Proposed rear elevation
Outline of fenestration to be removed shown dotted

DO NOT SCALE THIS DRAWING WRITTEN DIMENSIONS ONLY TO BE USED ALL DIMENSIONS ARE IN MILLIMETRES ALL DIMENSIONS TO BE VERIFIED ON SITE ANY INCONSISTENCIES TO BE REPORTED TO THE ARCHITECT IMMEDIATELY	Job No 7155		p-ad 192D Compden Hill Road, Notting Hill Gate, London, W8 7TH t: 0208 4590172 e: info@p-ad.co.uk		p-ad	
	FOR CONSTRUCTION					
	87-93 Kingsgate Road, London, NW6 4LA		Title	NMA JUSTIFICATION		
			Drawn by SG	Scale 1:200 @ A3		Number 7155/GA /3.0

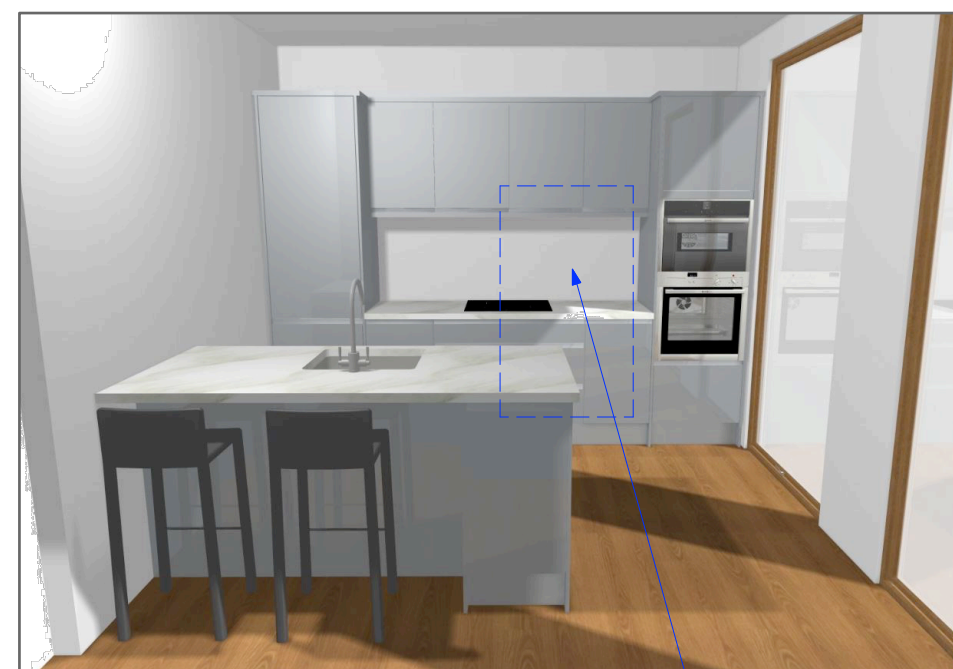
Reason for amendment:

The window is proposed to be removed to accommodate a more efficient kitchen layout. See plan extract and 3d image opposite

The kitchen/dining/living room would still benefit from a great deal of sunlight/daylight from the two full height window and large sliding doors on the side elevation

**KITCHEN
 PLAN EXTRACT**

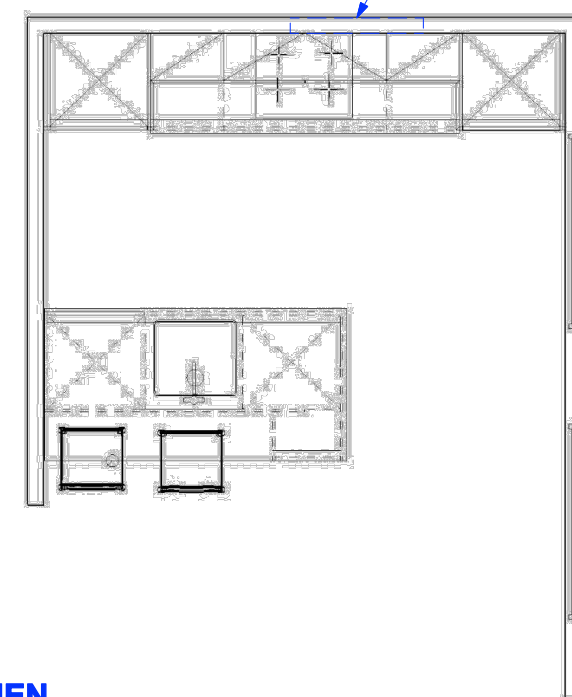
The window (indicatively shown dotted) would prevent the desired kitchen layout
